AUTOMATIC ADVANCE DIAGRAM

VACUUM ADVANCE DIAGRAM

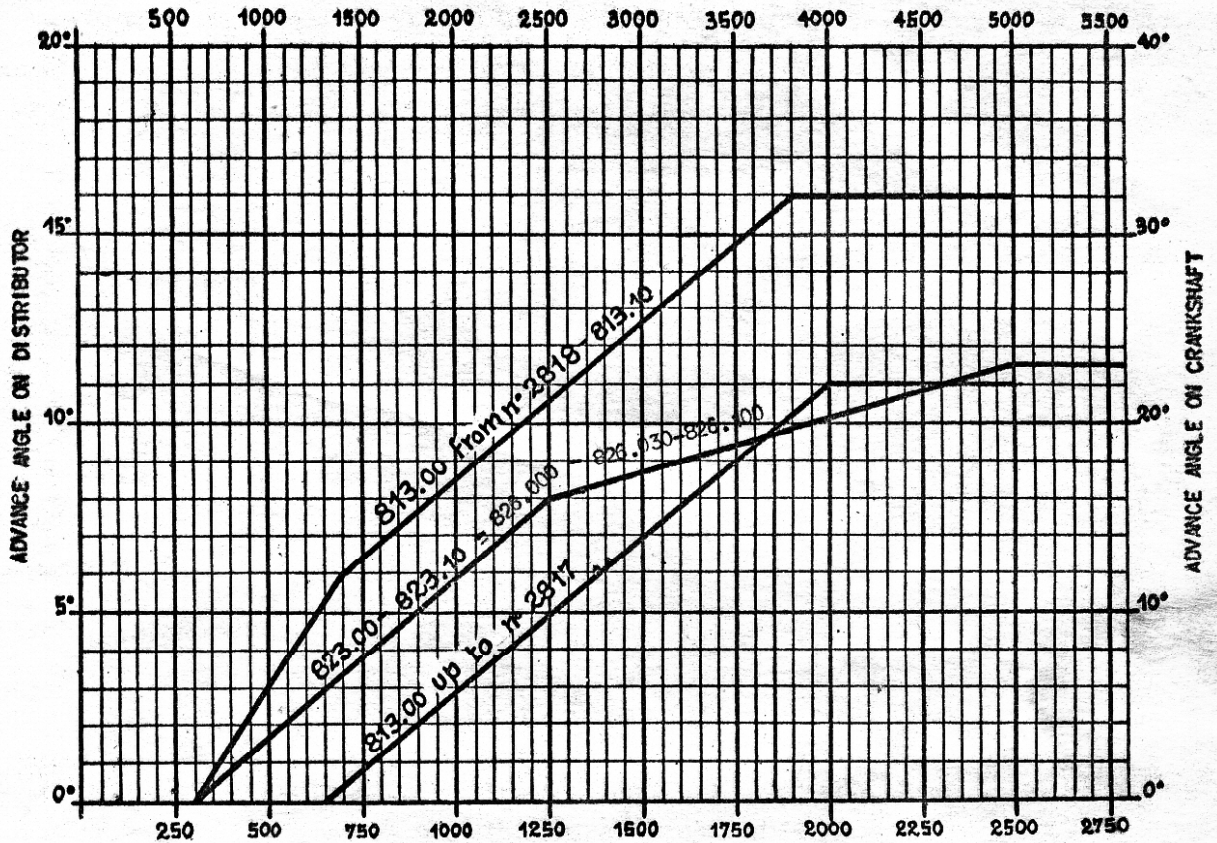
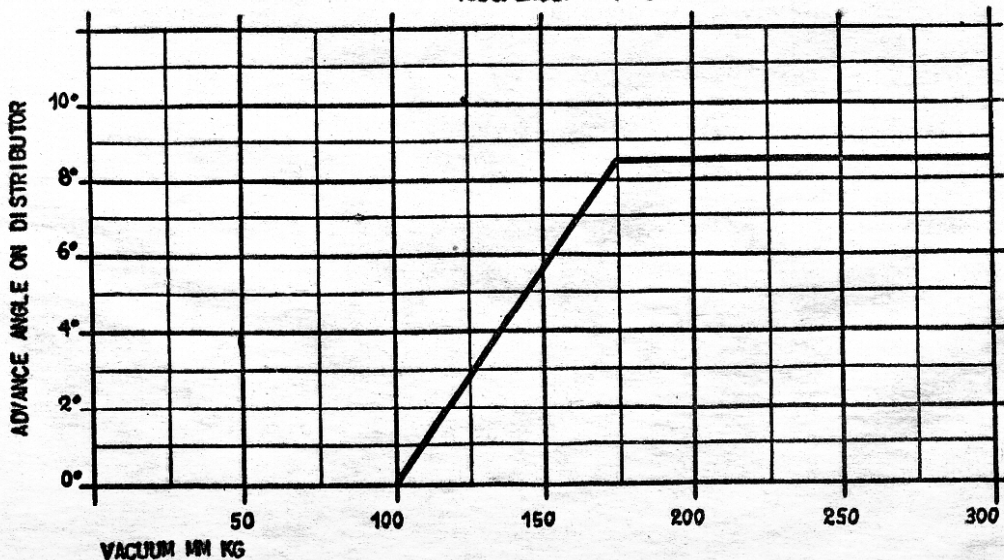
MODIFICATIONS: 2) 18/7/62 Modified data for engines 823.10
 BOGLIANI - T. 3/3/1963 Added data for engine 826.000-030-100-
